ADA Curb Ramp New Construction Inspection Form (Parallel)

Turel North-South Road Name 24952.54 Project No. Sheet No. Intersection No. Yorkshire East-West Road Name

PL
Ramp Style

PARALLEL RAMP (PL)

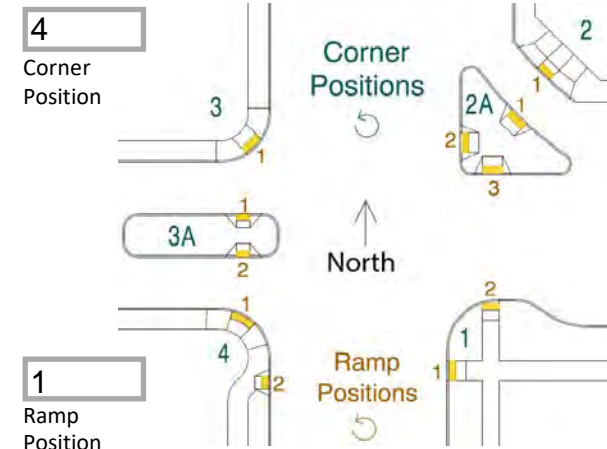
RAMP RUN 1	Pass	Fail
Running Slope 1	<input type="text" value="10.7"/> $\leq 2.0\%$ <input type="checkbox"/> $> 2.0\%$ <input checked="" type="checkbox"/>	<input type="checkbox"/>
Cross Slope 1	<input type="text" value="10.7"/> $\leq 2.0\%$ <input type="checkbox"/> $> 2.0\%$ <input checked="" type="checkbox"/>	<input type="checkbox"/>
Detectable Warning	<input type="text" value="N"/> Y <input type="checkbox"/> N <input checked="" type="checkbox"/>	<input type="checkbox"/>
Lip Height	<input type="text" value="0.5"/> $\leq 1/4"$ <input type="checkbox"/> $> 1/4"$ <input checked="" type="checkbox"/>	<input type="checkbox"/>
Gutter Flow Slope	<input type="text" value="8.8"/> $\leq *$ <input type="checkbox"/> $> *$ <input checked="" type="checkbox"/>	<input type="checkbox"/>
Curb Running Slope (avg)	<input type="checkbox"/> <input type="text" value="8.08"/> $\leq 8.3\%$ <input checked="" type="checkbox"/> $> 8.3\%$ <input type="checkbox"/>	<input type="checkbox"/>

Counter Slope (+/-)*2	<input type="text" value="4.7"/> $\leq 5.0\% $ <input type="checkbox"/> $> 5.0\% $ <input checked="" type="checkbox"/>	<input type="checkbox"/>
Det. warning full width of ramp	<input type="text" value="N"/> Y <input type="checkbox"/> N <input checked="" type="checkbox"/>	<input type="checkbox"/>

RAMP RUN 2	Pass	Fail
Running Slope 2	<input type="text" value="17.2"/> $\leq 8.3\%$ <input type="checkbox"/> $> 8.3\%$ <input checked="" type="checkbox"/>	<input type="checkbox"/>
Length 2	<input type="text" value="8.1"/>	<input type="checkbox"/>
Cross Slope 2	<input type="text" value="17.2"/> $\leq 2.0\%$ <input type="checkbox"/> $> 2.0\%$ <input checked="" type="checkbox"/>	<input type="checkbox"/>

RAMP RUN 3	Pass	Fail
Running Slope 3	<input type="text" value="7.3"/> $\leq 8.3\%$ <input type="checkbox"/> $> 8.3\%$ <input checked="" type="checkbox"/>	<input type="checkbox"/>
Length 3	<input type="text" value="7.3"/>	<input type="checkbox"/>
Cross Slope 3	<input type="text" value="2.1"/> $\leq 2.0\%$ <input type="checkbox"/> $> 2.0\%$ <input checked="" type="checkbox"/>	<input type="checkbox"/>

TURN SPACE	Pass	Fail
Width X	<input type="text" value="3.1"/> $\geq 4.0'$ <input type="checkbox"/> $< 4.0'$ <input checked="" type="checkbox"/>	<input type="checkbox"/>
Length Y	<input type="text" value="4.9"/> $\geq 4.0' * 1$ <input checked="" type="checkbox"/> $< 4.0' * 1$ <input type="checkbox"/>	<input type="checkbox"/>
Back of Ramp Obstruction (Y/N)	<input type="text" value="N"/> $\geq 5.0' * 1$ <input type="checkbox"/> $< 5.0' * 1$ <input type="checkbox"/>	<input type="checkbox"/>
Slope X (Cross Slope 1)	<input type="text" value="10.7"/> $\leq 2.0\%$ <input type="checkbox"/> $> 2.0\%$ <input checked="" type="checkbox"/>	<input type="checkbox"/>
Slope Y (Running Slope 1)	<input type="text" value="10.7"/> $\leq 2.0\%$ <input type="checkbox"/> $> 2.0\%$ <input checked="" type="checkbox"/>	<input type="checkbox"/>

MISCELLANEOUS	Pass	Fail
Clear Width (feet)	<input type="text" value="3.1"/> $\geq 4.0'$ <input type="checkbox"/> $< 4.0'$ <input type="checkbox"/>	<input type="checkbox"/>
Intersection Control Type	<input type="text" value="SY"/> Slope of Rd. <input type="text" value="9.0"/>	<input type="checkbox"/>
Horizontal Gaps	<input type="text" value="0.5"/> $\leq 1/2"$ <input type="checkbox"/> $> 1/2"$ <input checked="" type="checkbox"/>	<input type="checkbox"/>

Comments:
No Td.
